WILLIAMSON COUNTY, TEXAS

CHANGE ORDER NUMBER: 2

Project: 22IFB39

Roadway: CR 111

WILLIAMSON COUNTY CR 111 IMPROVEMENTS			
STORM SEWER PLAN & PROFILE			
SHEET 6 OF 6		SCALE: 1"=100'H 1"= 10'V	
DATE: 3/24/2022	DN:	DW:	CK: AP:
FED. RD. DIV. NO. 6	FEDERAL AID PROJECT NO. ----		SHEET NO. 154
STATE TEXAS	DIST. ---	COUNTY WILLIAMSON	
CONT. ----	SECT. --	JOB ---	HIGHWAY NO. CR 111

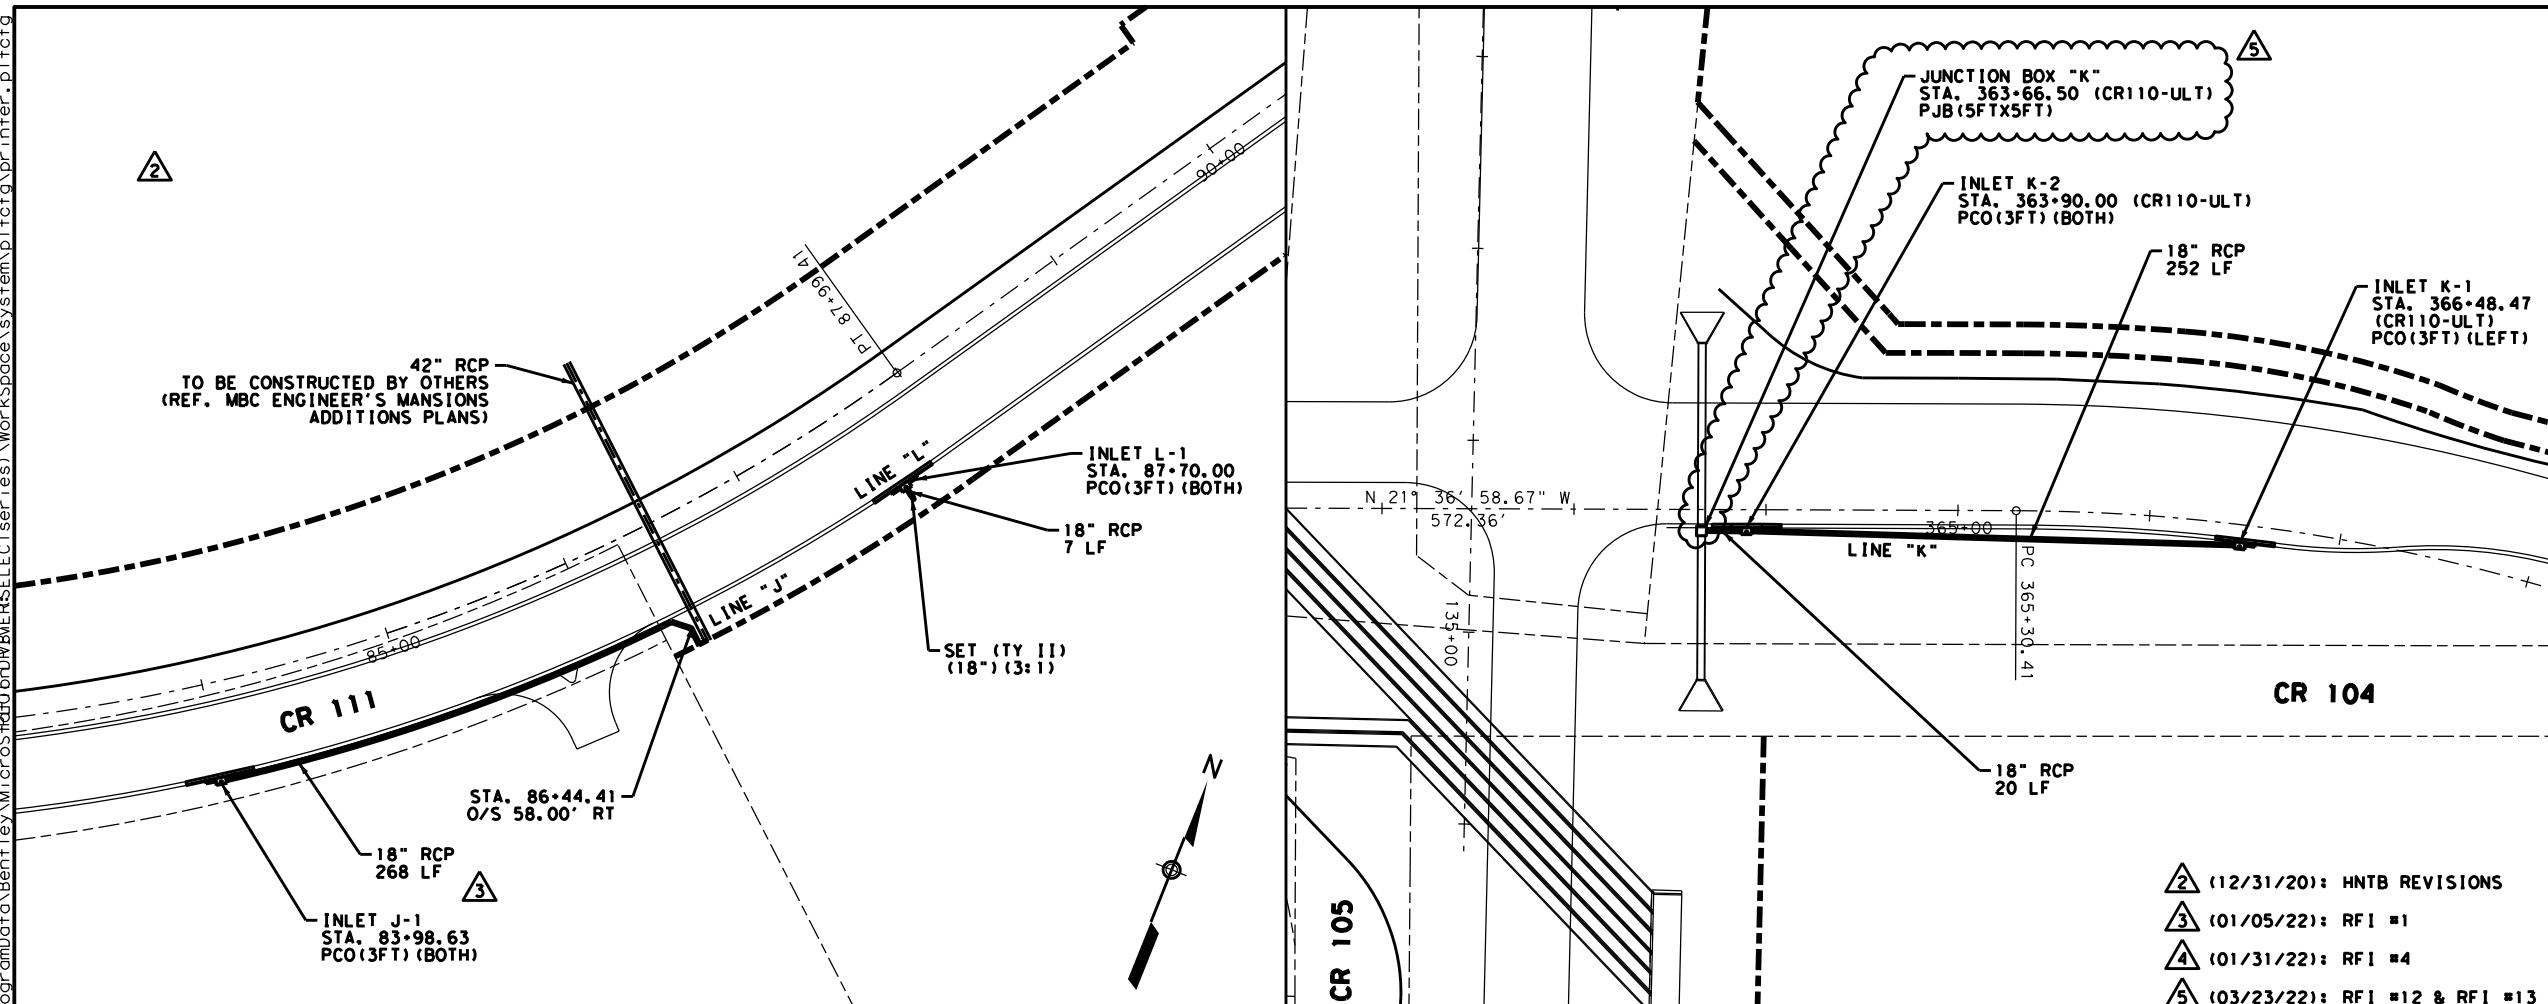
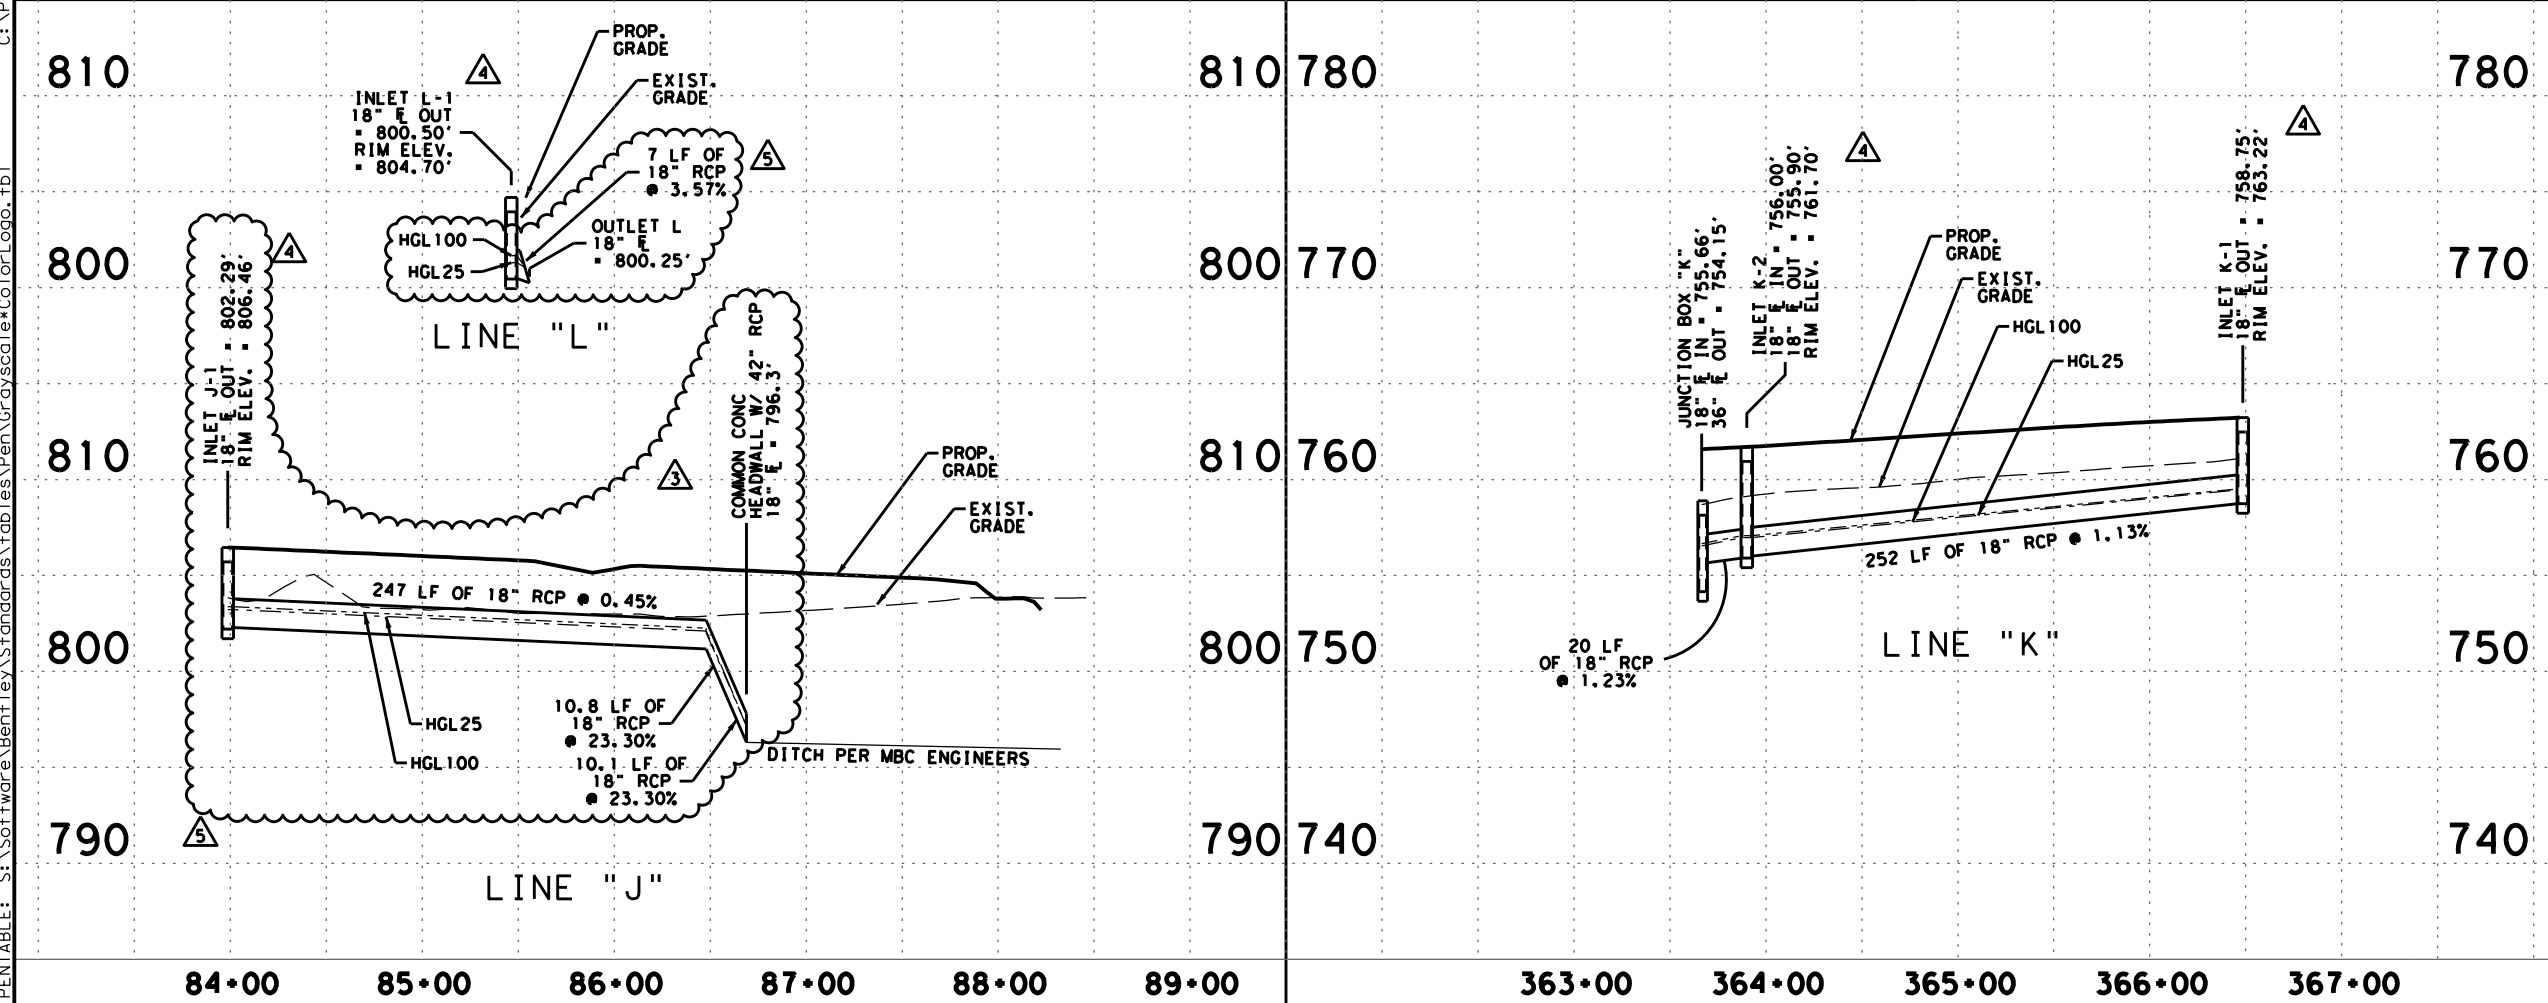
1B. Design Error or Omission. Other: This change order compensates the Contractor for upsize changes in 6 inlet and 1 junction box to accommodate pipe size design. The revisions affected estimate page 15, summary page 18, storm drainage pages; 149 for Inlet C-5 and C-6, page 150 for Inlets E-4 and E-5, page 151 for Inlet F-6, page 153 for Inlet I-6 and page 154 for Junction Box K.

Scope: 1. Inlets C-5, C-6, E-4, E-5, F-6, and I-6 upsized to 4' x 5' to accommodate pipe sizes.
2. JB-K upsized to 5' x 5' to accommodate pipe sizes
